# Colonial Durham Associates

*Destroying* 17,400+ sf of pervious land  
& *Deceptive* on “no restrictions”  
to College Brook flow

JOSHUA MEYROWITZ / 7 CHESLEY DRIVE, DURHAM, NH

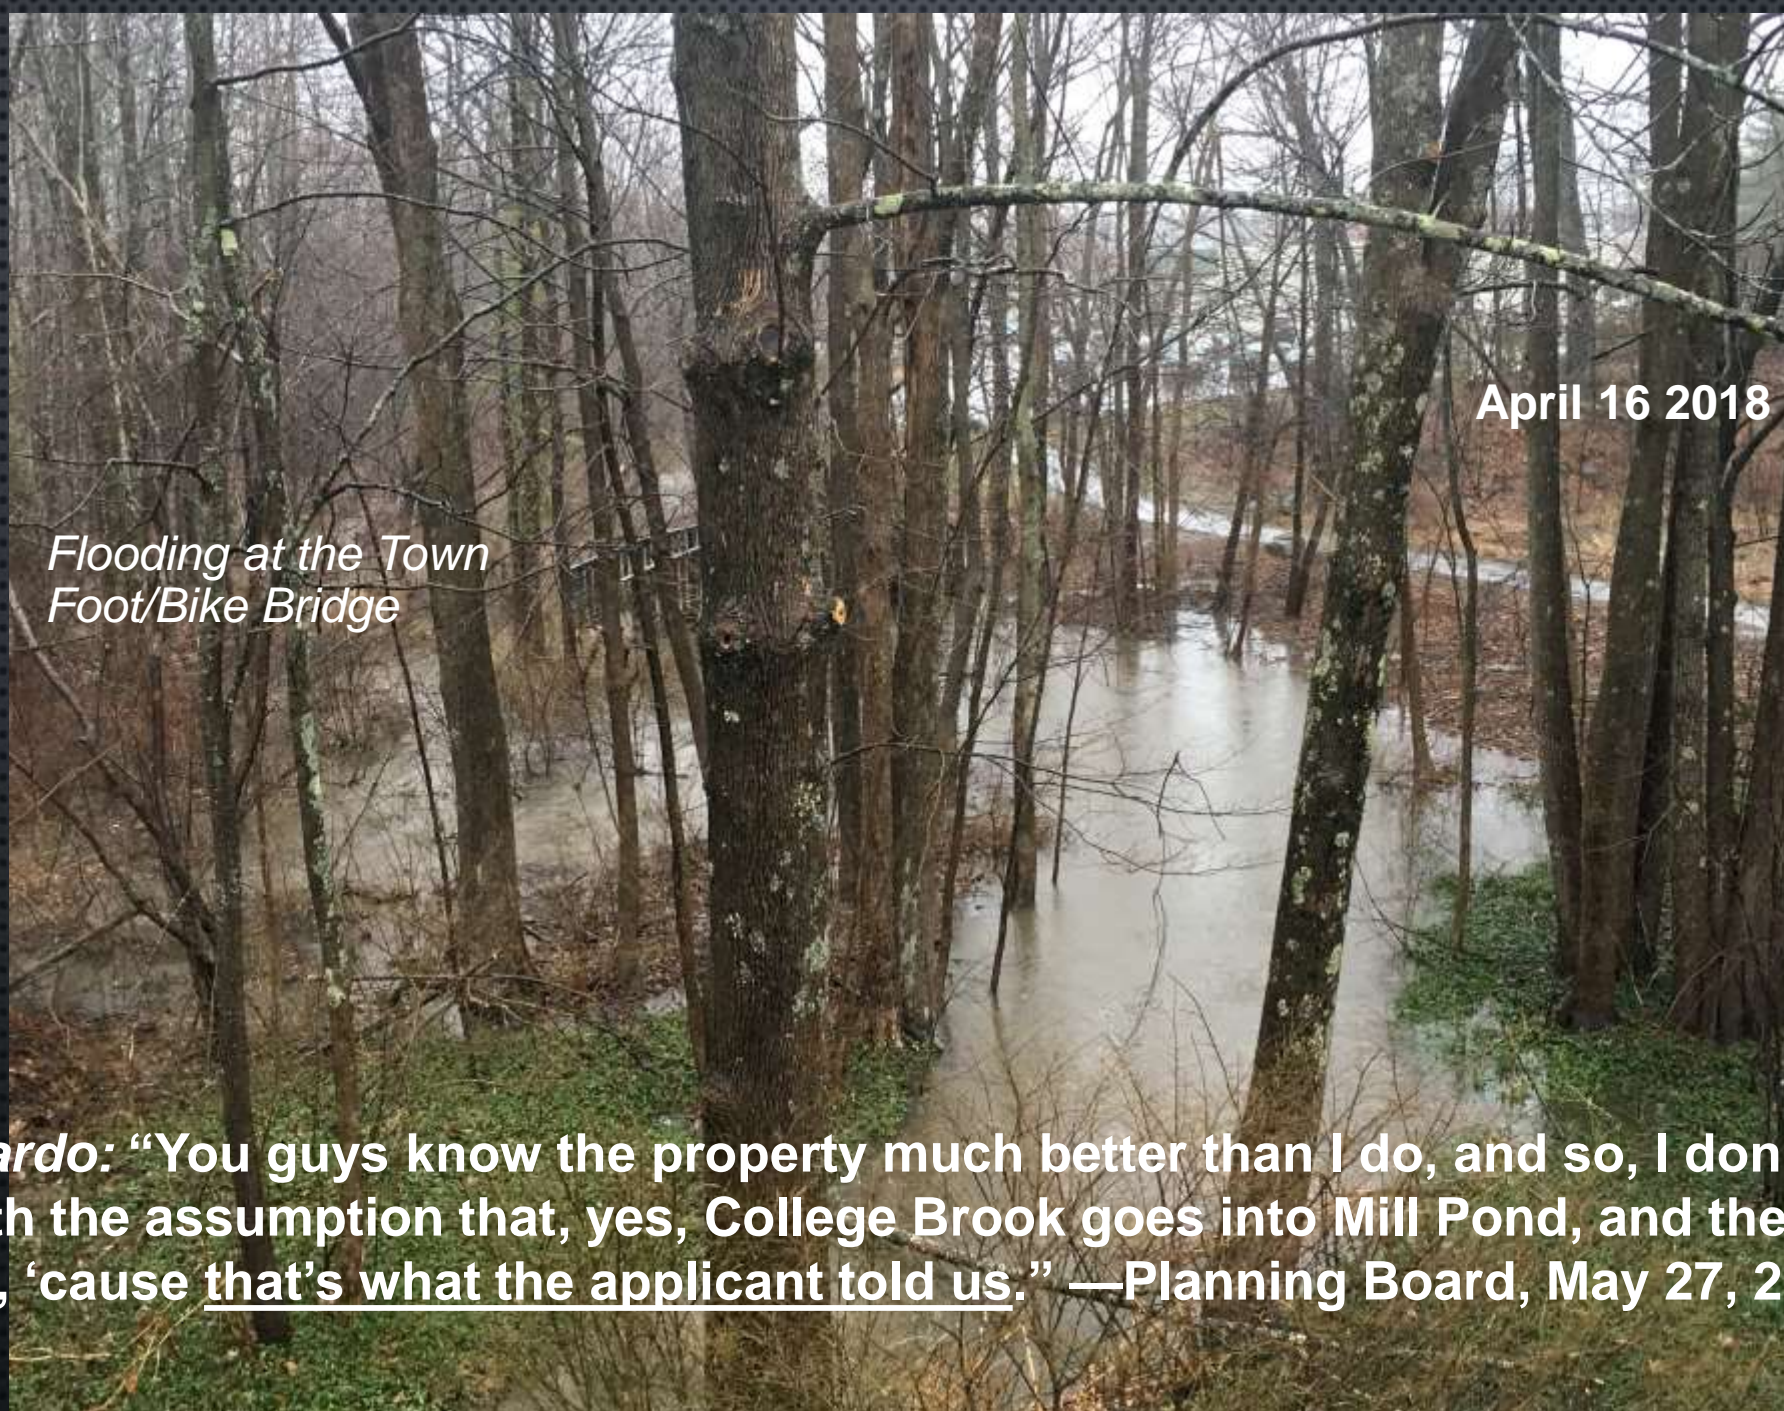
Flooding brings large objects that further “restrict” Brook’s flow

Raging brook brings: tires, luggage, lumber, tree trunks, other debris downstream ([26 sec video](#))

“The Applicant has clarified that College Brook flows to Mill Pond and stated that there are no restrictions that would cause the Brook to backup creating a flooding issue downstream. No further comment.” [HW 2<sup>nd</sup> Peer Review Report](#)

## PROPOSED

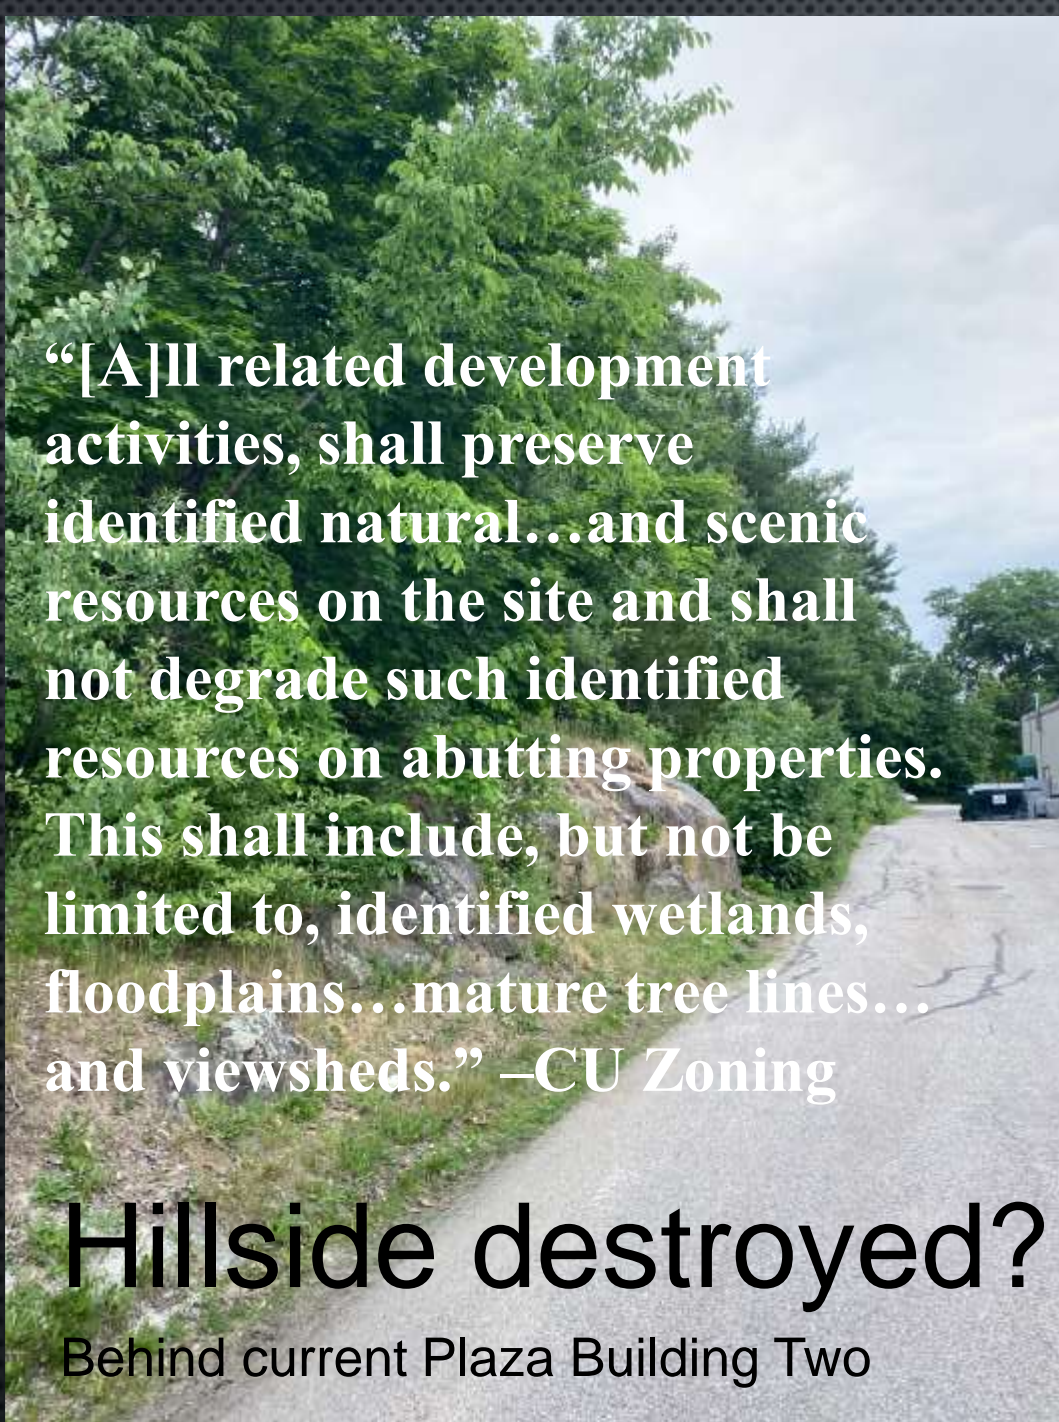
Existing one-story **Building Two** sits about 320-feet from the Chesley Marsh & College Brook Foot foot/bike bridge.

So-called “three-story” building (+13-ft-high retaining wall & 100ft paved deck) will turn 17,415 sf (+ cubic mass) of pervious vegetated slope into an impervious building.

Appears to come about **250 feet closer to the neighborhood, the Chesley Marsh, the College Brook flood zone** than the current single-story rear Plaza building.
